LiDAR Quality Assurance (QA) Report
Louisiana LiDAR ARRA Project - Region 2
October 11, 2011

Submitted to:
USGS

Prepared by:
 **Dewberry**

Figure 7 – 2nd delivery - corrected. Digital elevation model of tile 16RBT115865, second delivery. Missed ground points have been correctly classified for the second delivery. The feature no longer breaks at the point of the marker.

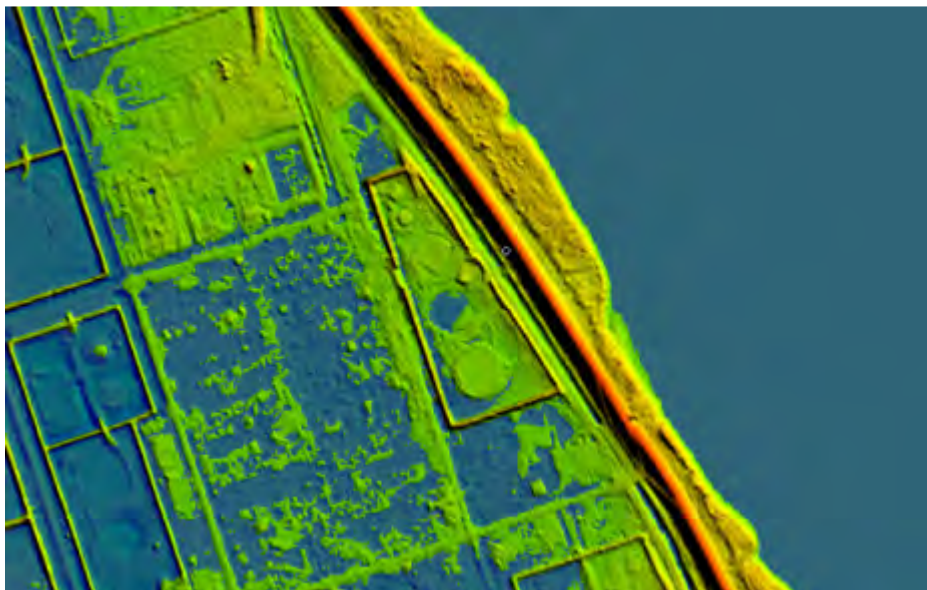
Figure 6 – 1st delivery. Ground elevation model DEM of tile 16RBT115865 showing an area that is misclassified (move Class1-unclassified to Class 2-ground).

Figure 9 – 2nd delivery - corrected. LAS tile 16RBT115940, second delivery. Vegetation artifacts in the area of the profile have been removed. Ground points, shown in purple in the cross section, now contain only those points low enough to be considered ground. The ground model appears smoother.

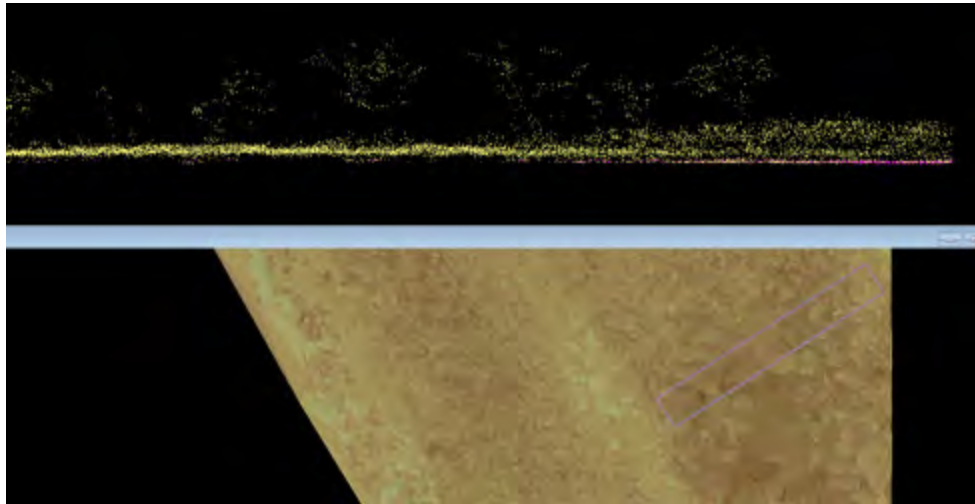
Figure 8 – 1st delivery. Full point cloud of tile 16RBT115940.las showing a vegetation artifact that is left in the ground model.

Figure 11 – 2nd delivery - corrected. Full point cloud LAS tile 16RBT895340. The vegetation artifact has been removed. No ground points (purple) are seen to be misclassified in the profile.

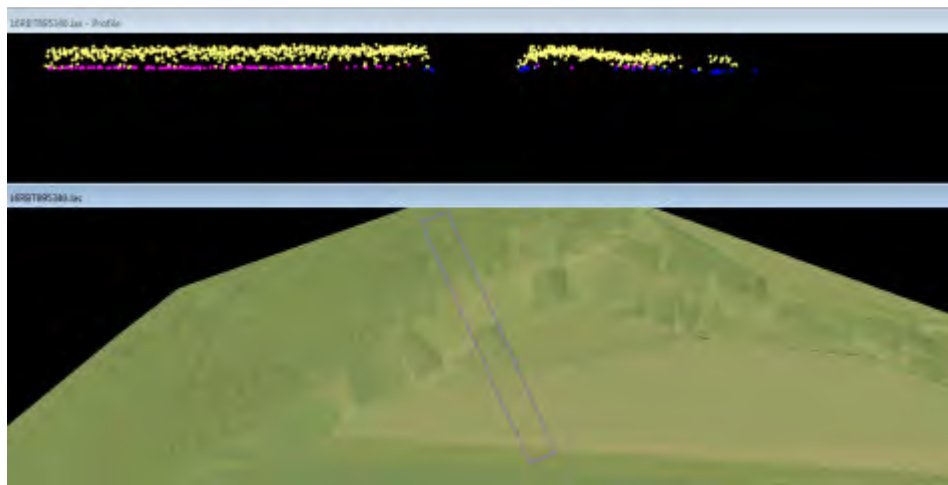
Figure 10 – 1st delivery. Full point cloud of tile 16RBT895340.las showing a vegetation artifact that is left in the ground model.

Figure 12 - Ground density model of tile 16RBU550480. The areas of red in this tile are data voids.

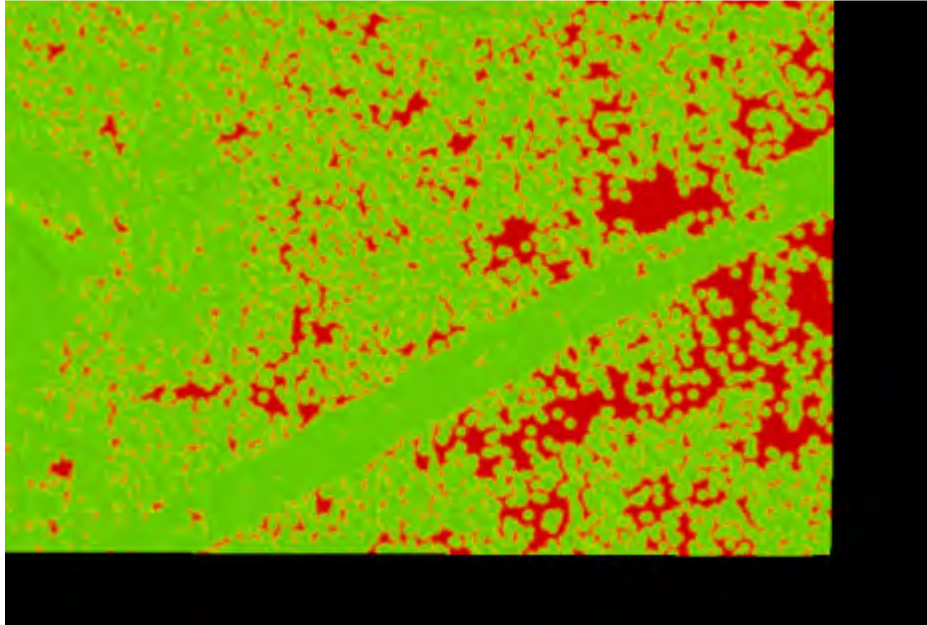
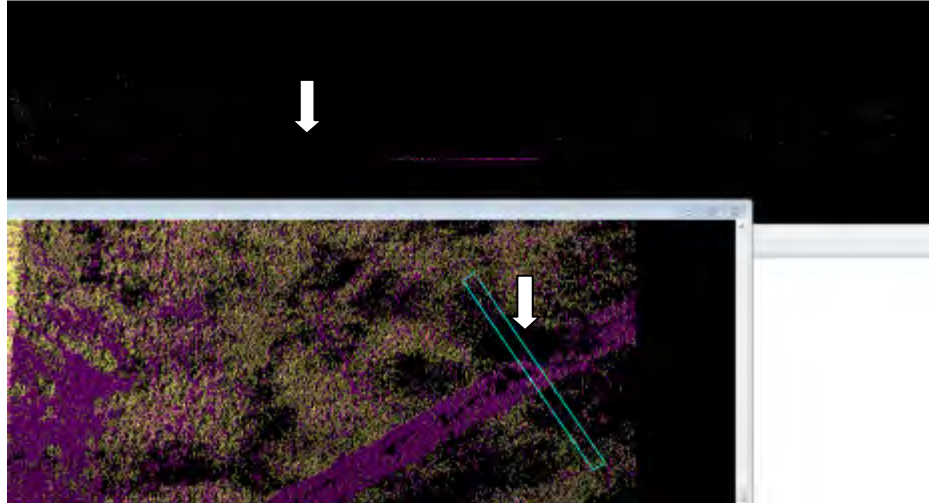
Data voids were identified in two areas resulting in 7 original calls. The voids seem to be related to areas where the intensity values are very dark (Figure 13). This error involves an anomaly with the LiDAR collection process. As seen in Figure 14 (the full LAS point cloud) no points were collected in the void areas. It would be costly and inefficient to fully correct for the void areas as the location would most likely need to be re-flown. Woolpert was unable to further correct the pictured tile below in the second delivery. However, Dewberry feels that because the voids are not widespread and are not of concerning size, they do not significantly impact the ground model. The void areas should be noted by the user but do not jeopardize the ground model or other LiDAR products.

Figure 14 - Full point cloud image of tile 16RBU550480 colored by classification. The profile and map view both show the data voids.

Figure 17 - Yellow dots show tiles that Dewberry recommends Woolpert deliver to ensure there is no ground.

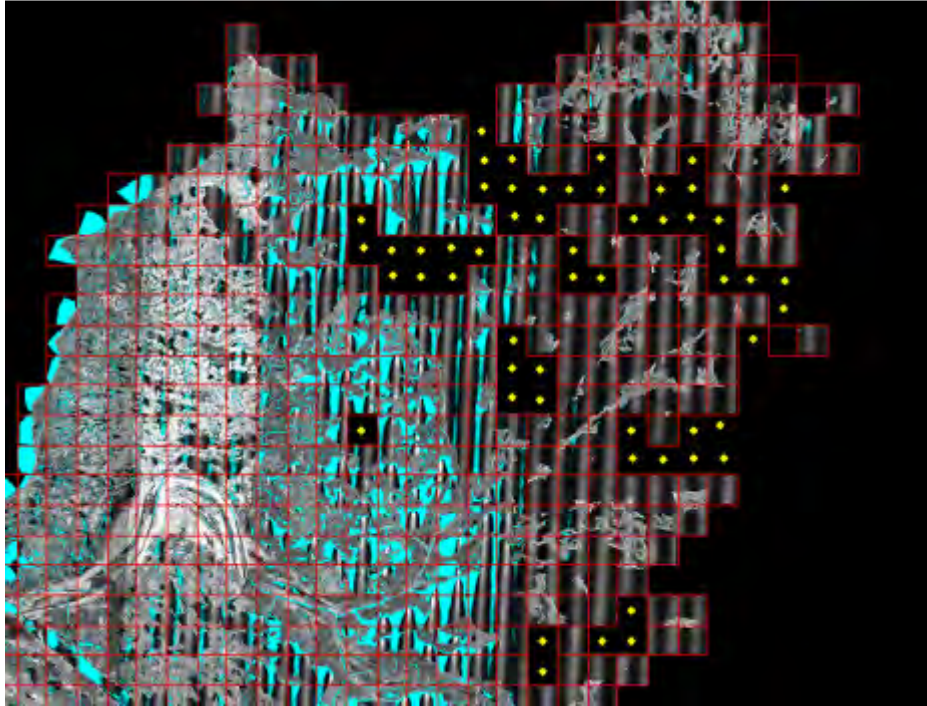
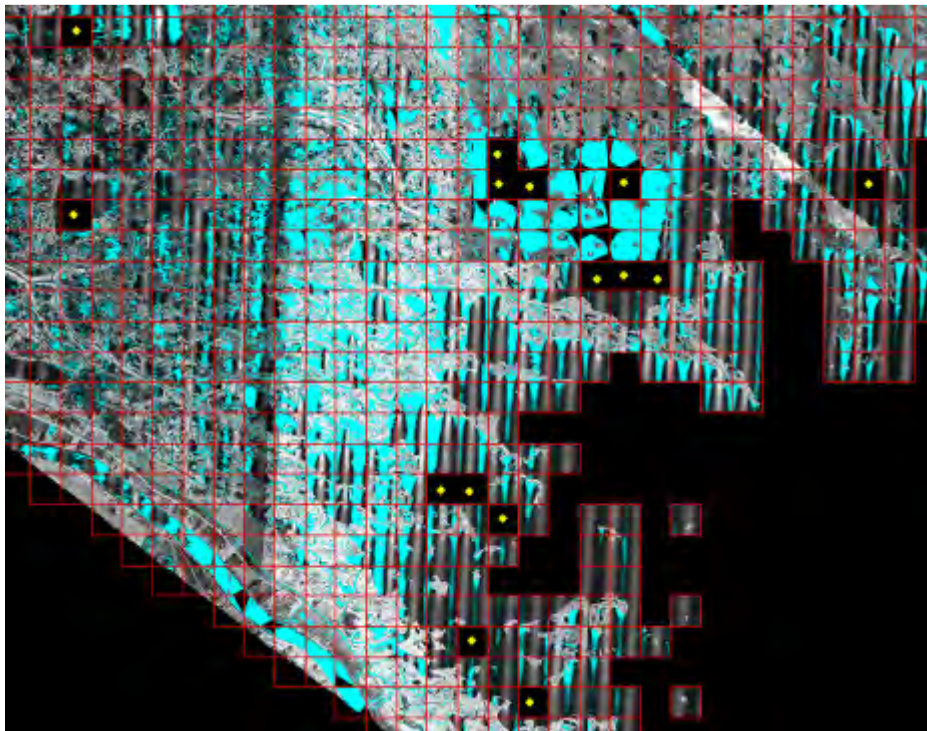
Figure 18 - Yellow dots show tiles that Dewberry recommends Woolpert deliver to ensure there is no ground.

Figure 24- 2nd delivery - Corrected. Full point cloud intensity image of tile 16RBU190135 with the second delivery breaklines. The two blue lines delineate a stream breakline. The islands breakline has now been correctly clipped to the streams breakline.

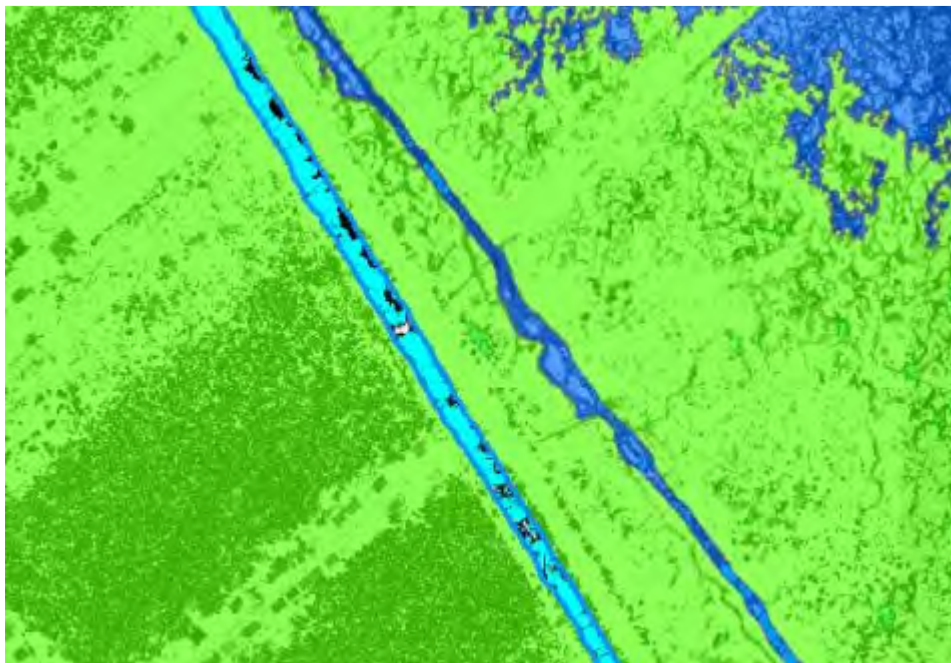
In the first delivery, the islands breaklines were not clipped at the extent of the streams breakline. This issue was fixed in the second breakline delivery. An example of the error and its correction is below in Figure 23 and Figure 24.

Figure 23 – 1st delivery. Full point cloud intensity image of tile 16RBU190135. The green area is the islands breakline and the two blue lines delineate a stream breakline. The islands should be clipped at the stream lines.

Figure 32 – 2nd delivery - Corrected. Full point cloud intensity image with tidal waters (blue) and islands (green) draped over showing a water body that not captured.

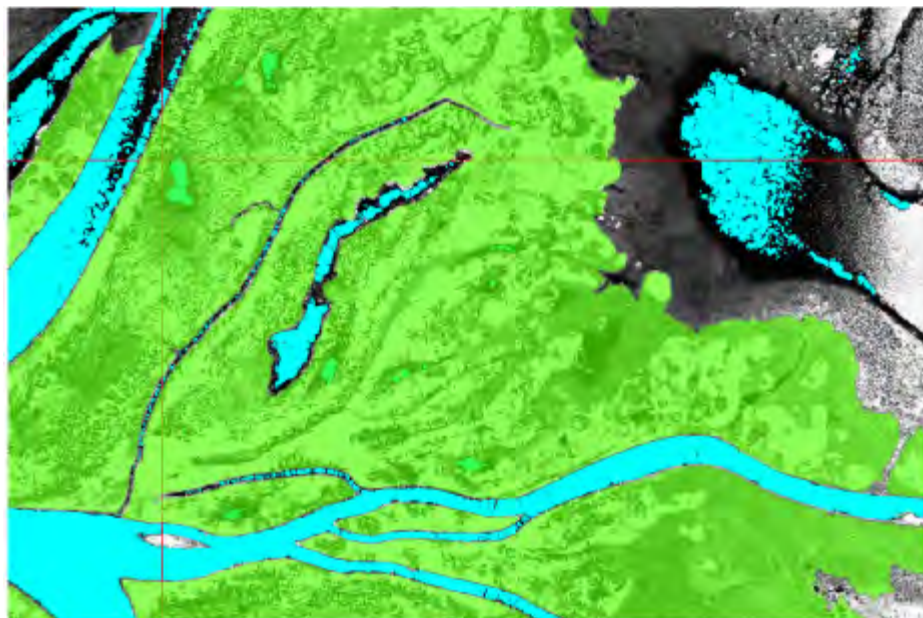
Figure 31 – 1st delivery. Full point cloud intensity image with tidal waters (blue) and islands (green) draped over showing a water body that was not captured.

Figure 8 – A LiDAR ground density model showing low point density areas in red. The majority of red in the tile is water and not an error however the linear geometry of the void shown by the arrow implies that the void is legitimate. Tile 15RYN650295.

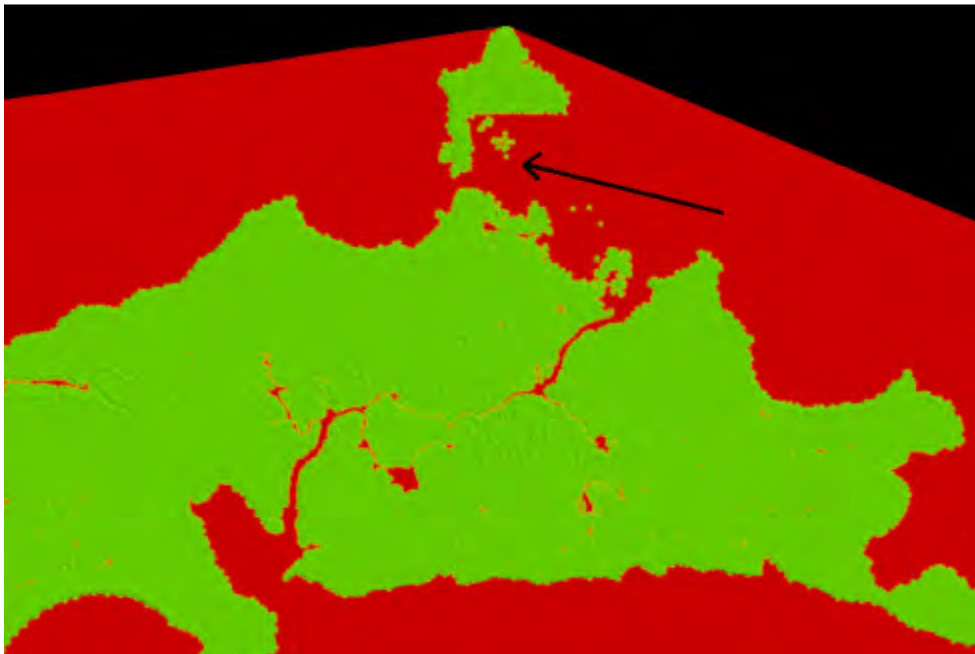
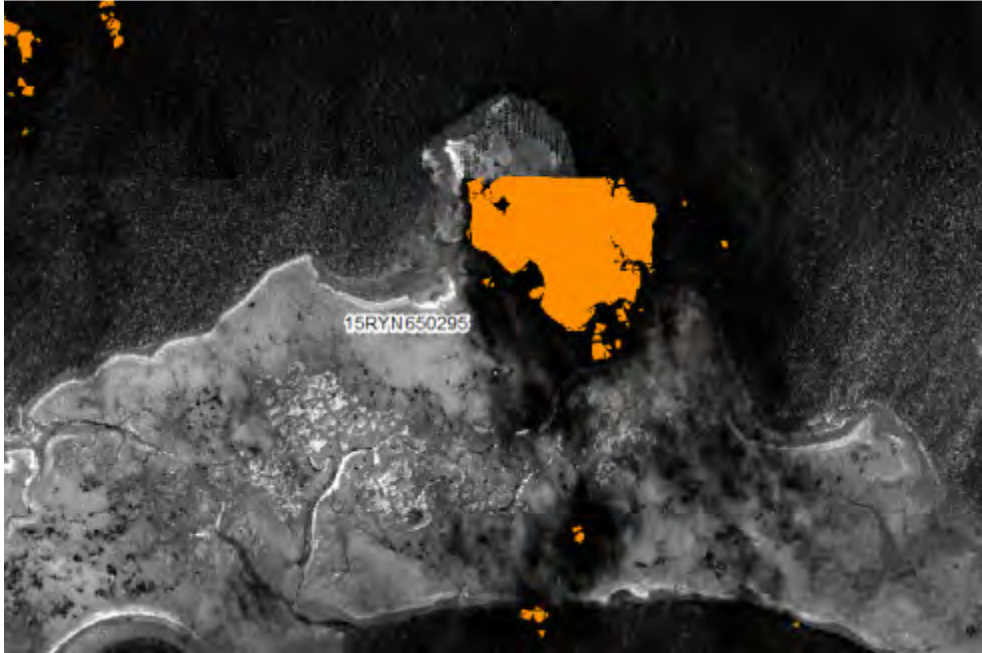
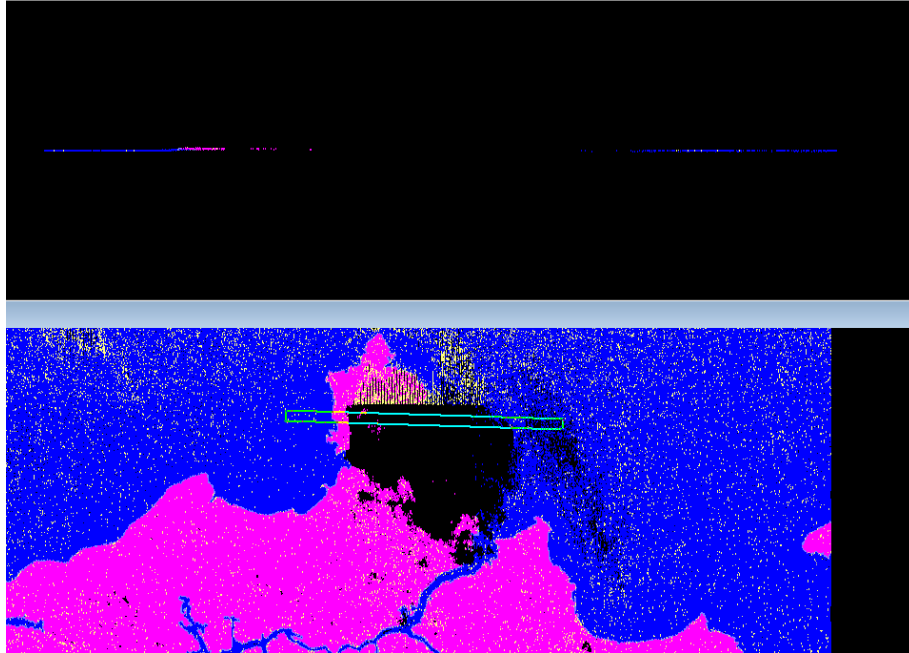
One Data void was identified in tile 15RYN650295. The void occurs in areas where the intensity values are very dark (Figure 8 to Figure 11). Because no points were collected in the void areas, they may be difficult and costly to fully correct, however users should be made aware of any data voids left in the final products. Woolpert responded to this issue and stated that “there is no available lidar coverage in this area due to excessive cloud cover.” Dewberry notes this here for the end-client.

Figure 9 – LiDAR intensity image of the same ground feature shown in Figure 13. Voids areas where no points were collected are colored orange. The large void here intrudes on the geography in an unnatural way. The void measure approximately 5.3 acres.

Figure 11 – LAS profile of tile 15RYN65029 colored by classification (where ground is shown in pink, water in blue and unclassified point in yellow.) No LiDAR points were collected in the void area.

Figure 17 - DeltaZ image from project area, first delivery. Red and yellow areas represent places where the flight line overlap difference is greater than 10cm and is therefore out of project specifications.

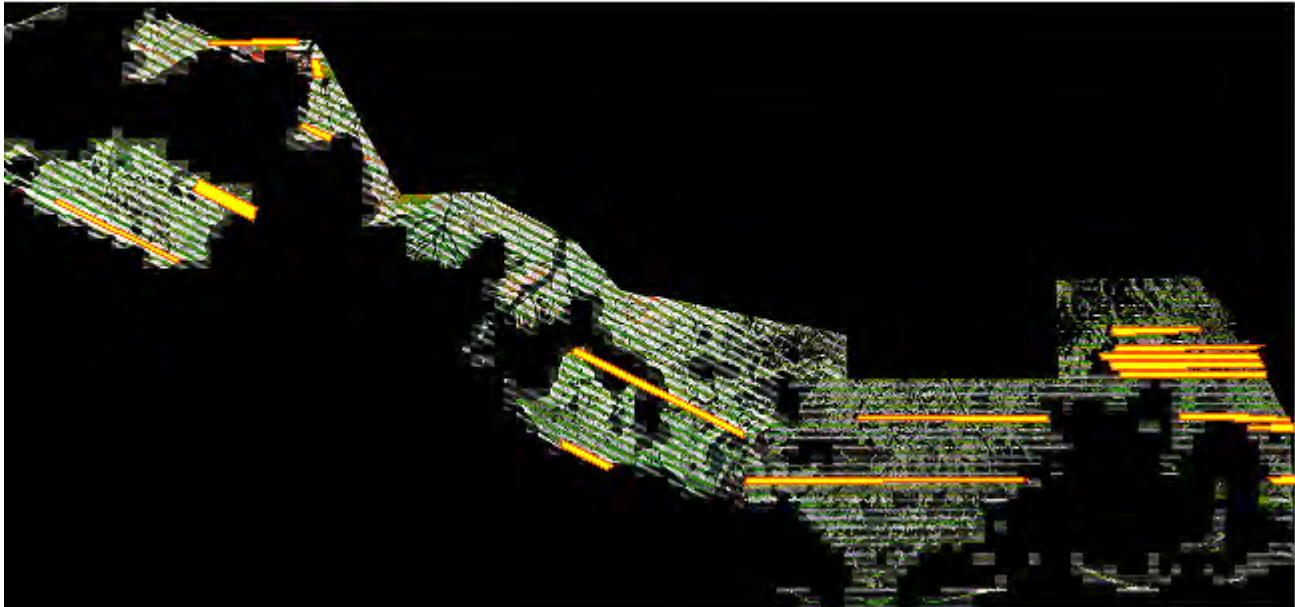
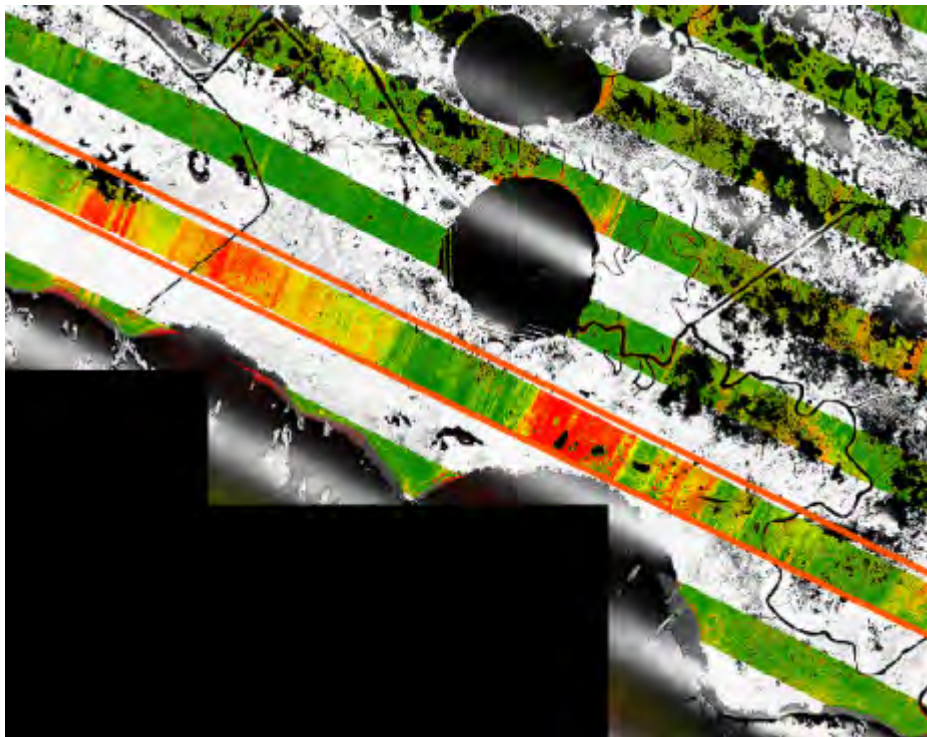
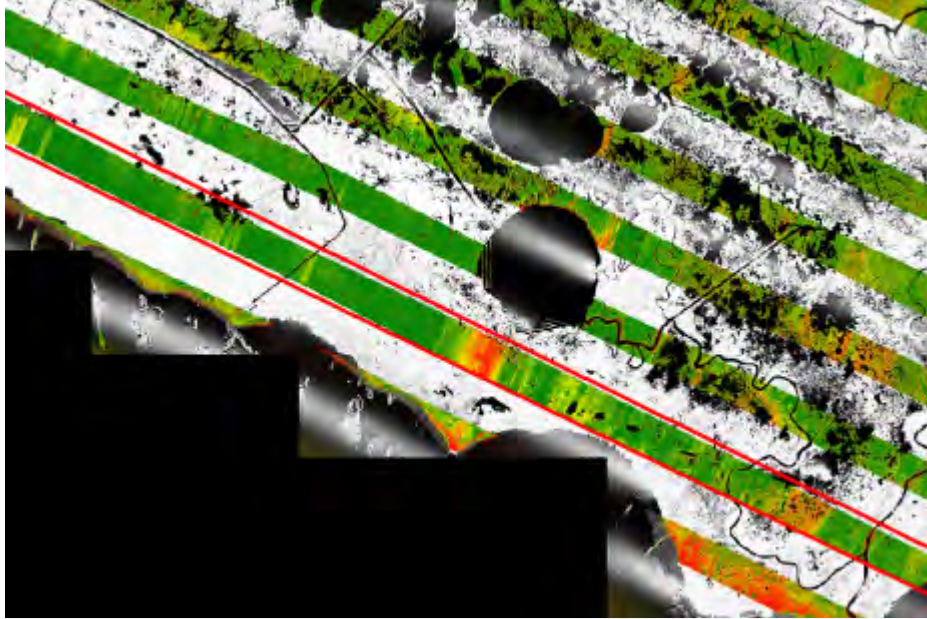
Figure 16 - Project wide area showing the 17 flight lines (highlighted in yellow), in the first delivery, that were addressed by Woolpert.

Figure 18 - DeltaZ image from project area, second delivery. Woolpert greatly reduced the flight line overlap in the dataset in the second delivery.

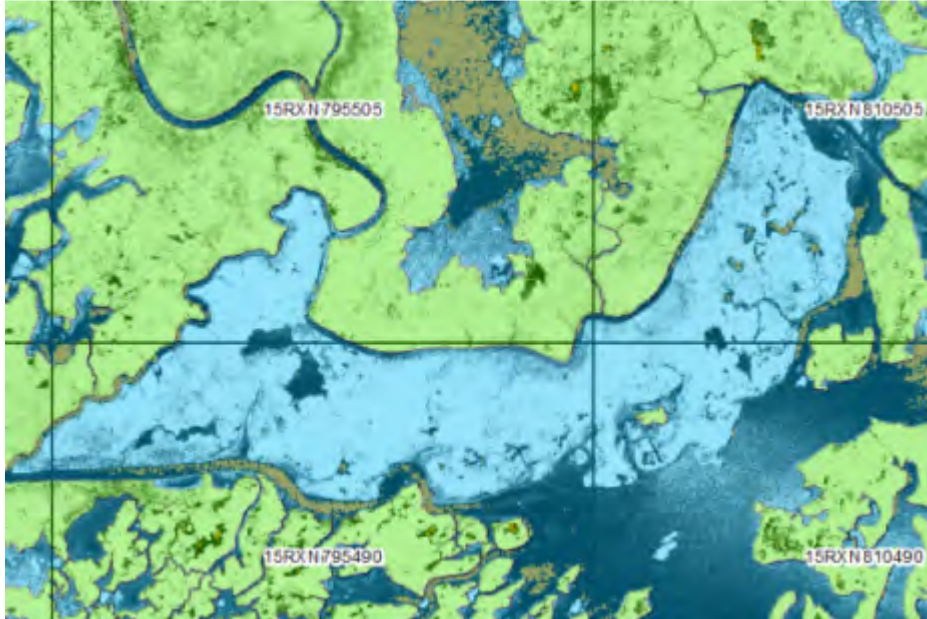
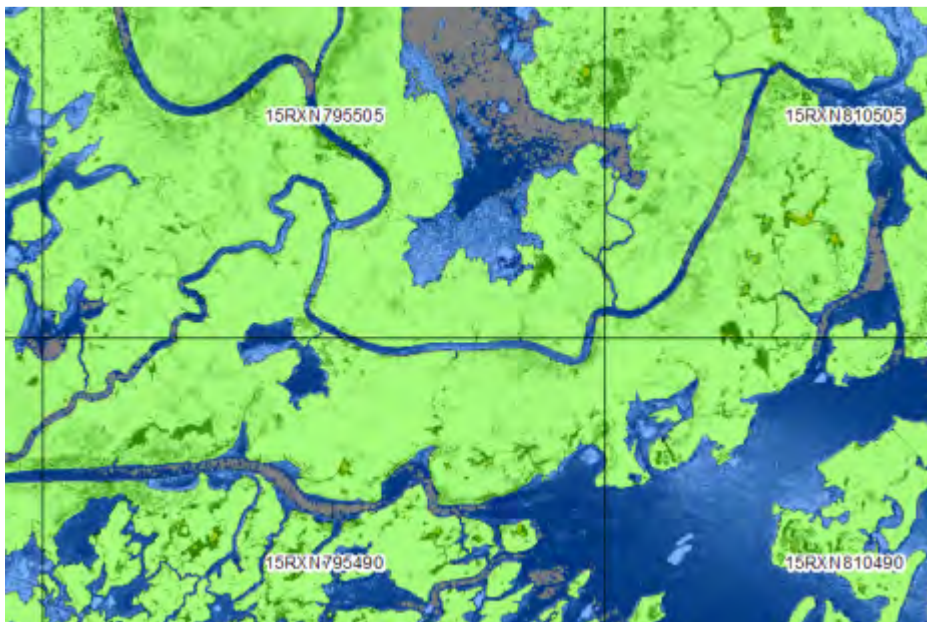
One large island was not captured as ground by the island breaklines. The island is approximately 250 acres. Woolpert corrected this issue in the second delivery. An example of the issue and its correction can be seen below in Figure 19 and Figure 20. No further issues remain with this call in the second delivery.

Figure 19 - Island breaklines are colored transparent green, Tidal water breaklines are transparent blue. The LiDAR intensity image is visible underneath the breaklines. A large land mass measuring approximately 250 square acres was not captured by the island breaklines. The island exists above the zero-elevation contour line.

Figure 20 - Island breaklines are colored transparent green, Tidal water breaklines are transparent blue. The LiDAR intensity image is visible underneath the breaklines. The large land mass has now been correctly added to the island breaklines dataset.
